Appl. No.: 10/055,771
Docket No.: H2022-00002
Amtd. dated May 16, 2003
Reply to Office action December 19, 2002

REMARKS

FIG. 2
(PRIOR ART)

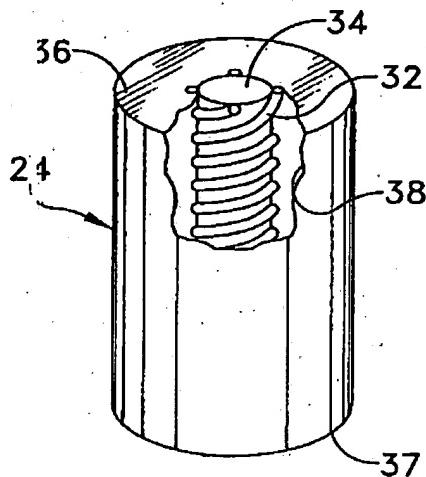
With regard to Item 1, attached to this Amendment is a proposed corrected Figure 2, including the legend -- Prior Art -- as required by the Examiner. In particular, the legend -- Prior Art -- has been placed between parentheses and below the identifier "Fig. 2." No new matter is introduced into the Application as a result of this change to Fig. 2. Reconsideration of the Examiner's objection to Fig. 2, and introduction of new Fig. 2 into the application are requested.
